Road Safety Audit
Stage 1
for
BRAY SUSTAINABLE TRANSPORT BRIDGE
BRAY, CO WICKLOW

Date: September 2020

Report produced by: Road Safety Matters Ltd

Reference: RSM/MOB/130320/DARGLE BRIDGE-RSA1

Figure 50: Shared Routes terminating suddenly

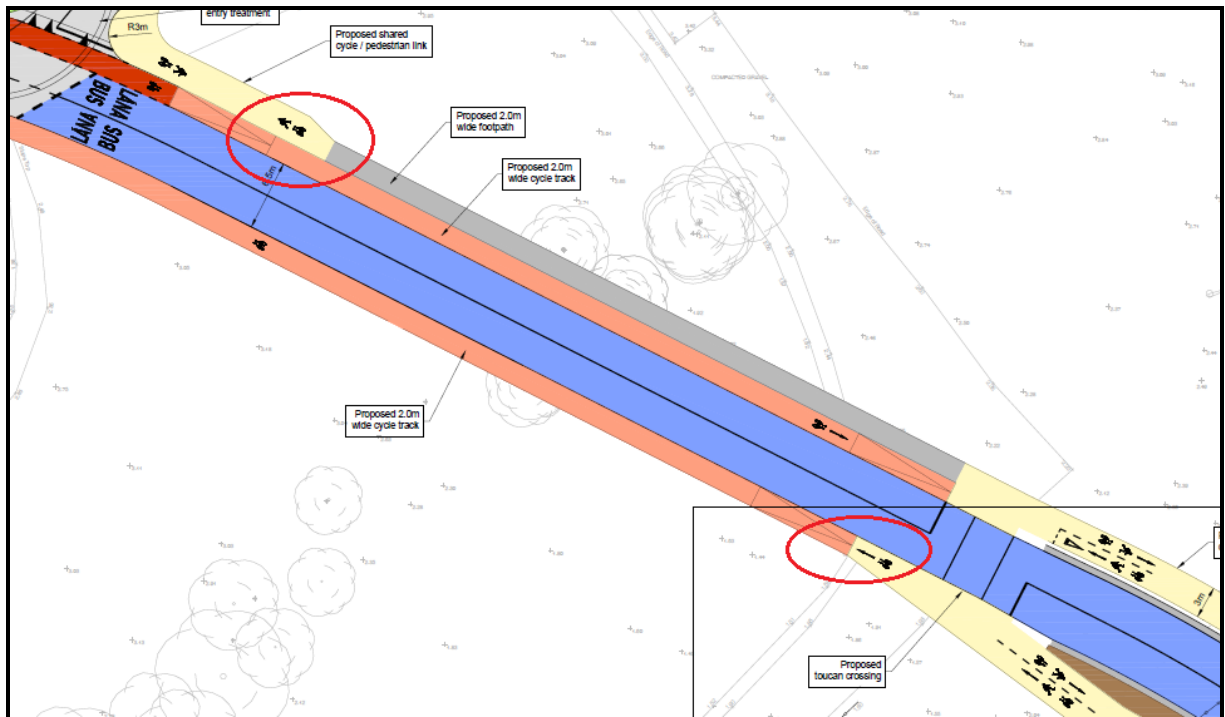
2.2.3.4 A shared VRU facility has been provided to each side of the proposed toucan crossing, however the pedestrian facility terminates abruptly on the southwestern side of the carriageway, as shown in figure 50, which may bring pedestrians into conflict with cyclists. The shared facility also terminates abruptly at Junction 1.

The continuity of the shared facilities should be considered in the context of kerb heights and potential trip hazards, and facilities should not terminate abruptly without suitable signing and lining guidance or provision for safe crossing facilities or transition kerbs. Consideration should also be given to the extension of the shared facilities and relocation of the proposed toucan crossing to a position further away from the proposed bridge.

Figure 51: Bridge Structure Height and Location will compromise Intervisibility

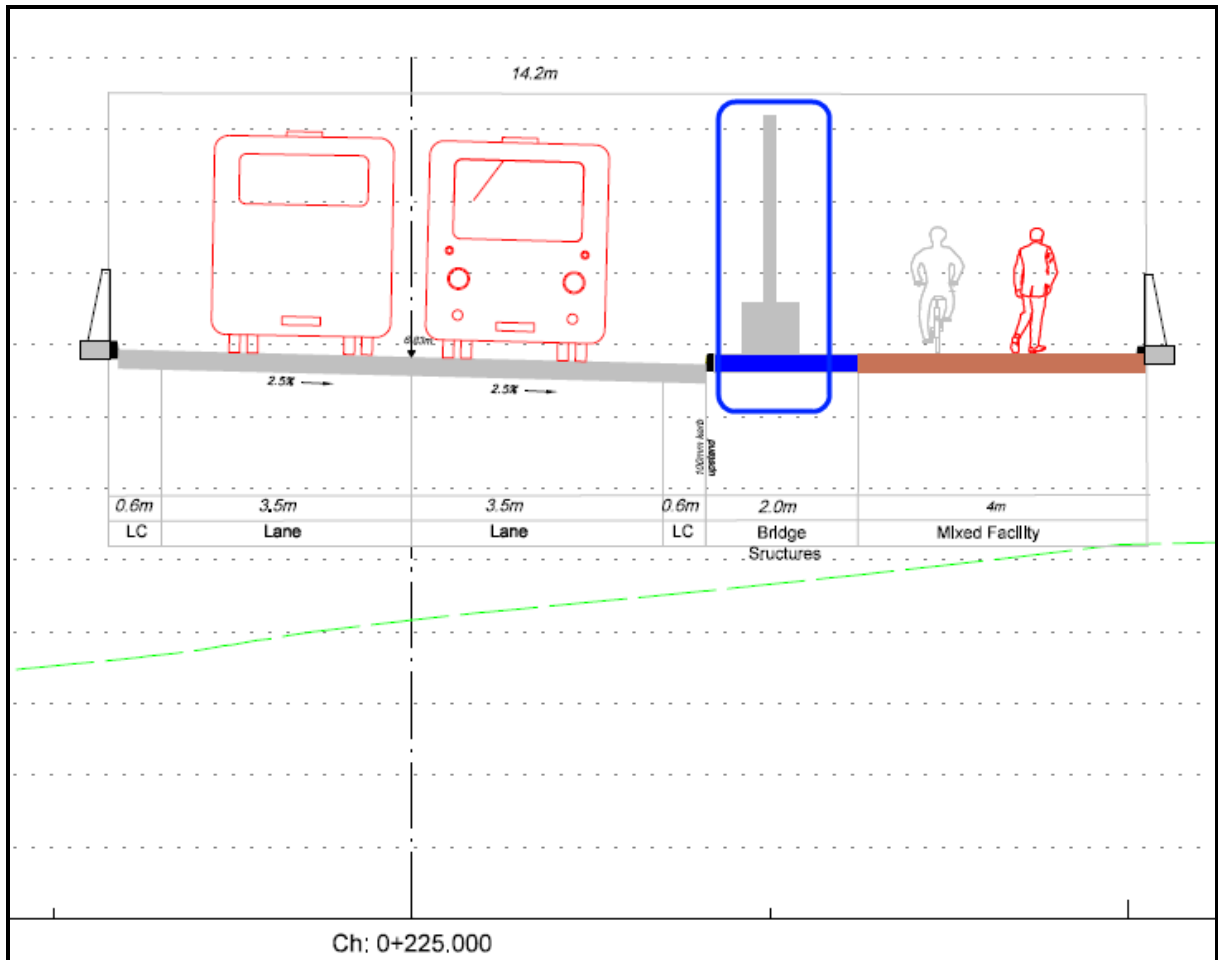
The proposed toucan crossing is located on a downhill gradient after a crest curve which coincides with a horizontal curve, which may present reduced visibility towards the crossing in the northbound direction. A vertical visibility drawing has been provided, based on an SSD of 49m, which allows little or no margin of error for large vehicles, potentially travelling at speed and needing to break suddenly on a downhill gradient, including in wet and icy conditions, where there is no provision for the standard 50m anti-skid surfacing which is required in advance of a controlled crossing in an urban environment. There was no horizontal visibility drawing provided,

and the combination of horizontal and vertical curvature can lead to further reductions in forward visibility and SSD. It was noted that the location of the bridge abutment on the eastern side and the high bridge structure on the western side, which is highlighted in the cross section in figure 51, and on the plan in figure 52, will further restrict intervisibility at this location, and lead to an increased risk of failure to stop, and VRU/vehicular conflict at the crossing.

Pedestrians and cyclists waiting to cross should be clearly visible from a point 2m back from the kerbline on both sides of the crossing, and both primary and secondary signal head aspects should also be clearly visible on approaches. Obstructions to clear intervisibility between VRUs and motorists should be removed, or the toucan relocated to a position which is further away from the crest curve and the bridge structure. Provision should be made for anti skid surfacing for a minimum 50m distance back from the stop lines on approaches to the crossing, and the crossing should ideally be raised to assist with traffic calming and maintaining low speeds on the link.

Figure 53: No Tactile at Conflict point between peds/cyclists or at junction

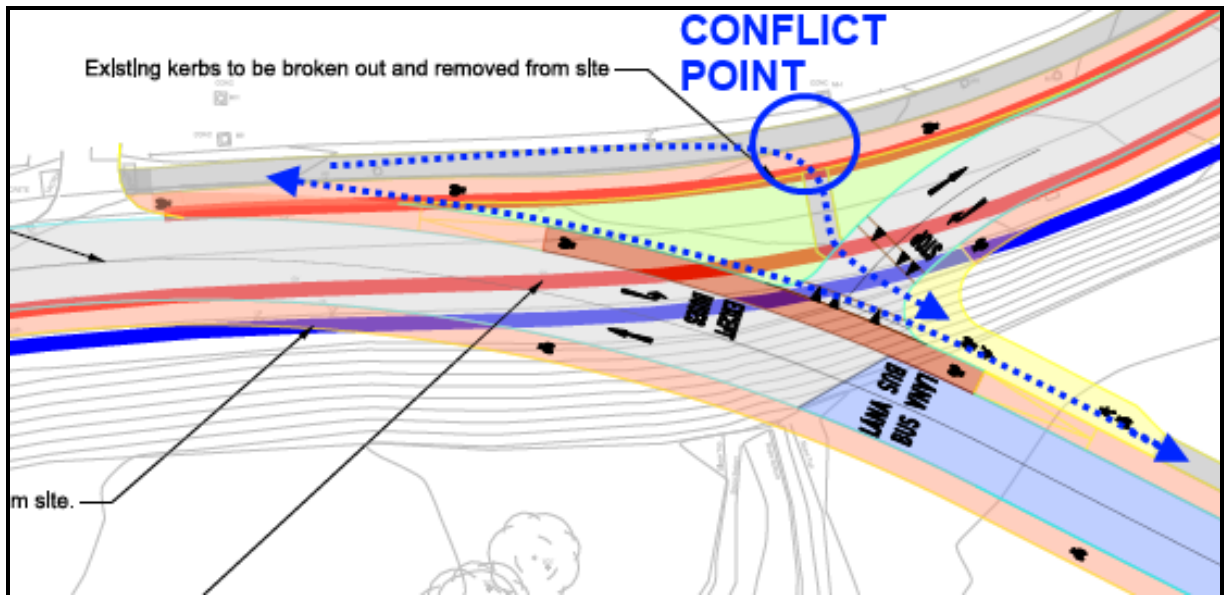
There is no provision for tactile paving at the proposed toucan crossing or at a number of informal crossing points throughout the scheme, or for ladder and tramline tactile paving at potential conflict points with cyclists, with an example of a potential conflict point shown in

figure 53, where there is no direct connectivity along the pedestrian desire line, and pedestrians will need to cross across cycle path.

Suitable tactile paving should be provided at all controlled and uncontrolled crossings throughout the scheme in accordance with standard requirements, to be accompanied by a suitable width dropped kerb with a maximum kerb upstand of 6mm. Details of proposed tactile paving (ladder and tramline) and signage and road markings at conflict points between pedestrians and cyclists at crossings should also be provided at detailed design stage. The location of all proposed street furniture, including signage and signal head poles, should ensure safe unimpeded movement is maintained for VRUs. Chamber covers should also be located away from pedestrian desire lines where possible, with finished levels to be flush with the surrounding pavement.
